Comments on location information request and response messages

Kanchei (Ken) Loa, Yi-Hsueh Tsai, Yung-Ting Lee, Shiann-Tsong Sheu, Hua-Chiang Yin, Frank C.D. Tsai,
Youn-Tai Lee, Heng-Iang Hsu, Chih-Chiang Hsieh
Institute for Information Industry

The purpose of this document is to comment subclause 6.3.2.3.65 location information request and response messages. In order to facilitate the incorporation of this proposal into IEEE 802.16j standard, specific changes to the baseline working document IEEE 802.16j-06/026r3 are listed below.

Figure uuu Relay location information request procedure – MR-BS

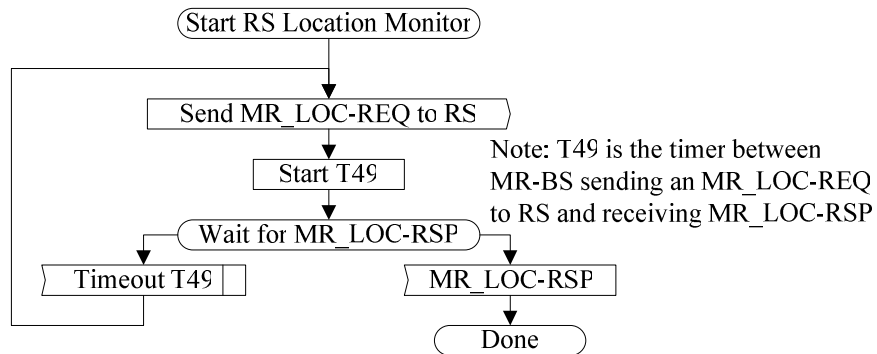
The flow charts (Figure uuu, and Figure vvv) on the following pages defines MR_LOC-REQ process that shall be followed by compliant RSs and MR-BSs.

Figure yyy Relay location information response procedure – RS

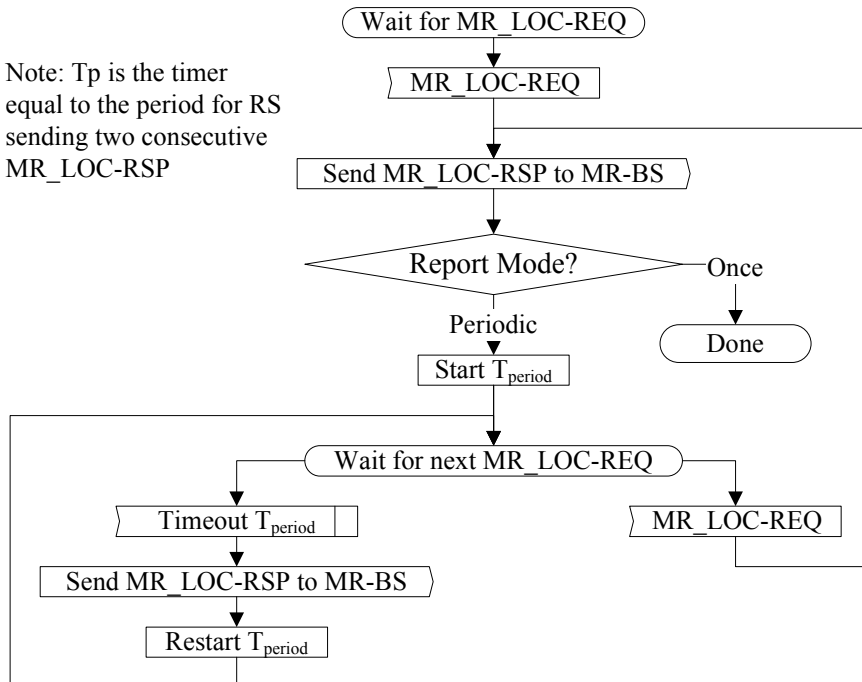
The flow charts (Figure xxx, and Figure yyy) on the following pages defines MR_LOC-RSP process that shall be followed by compliant RSs and MR-BSs.
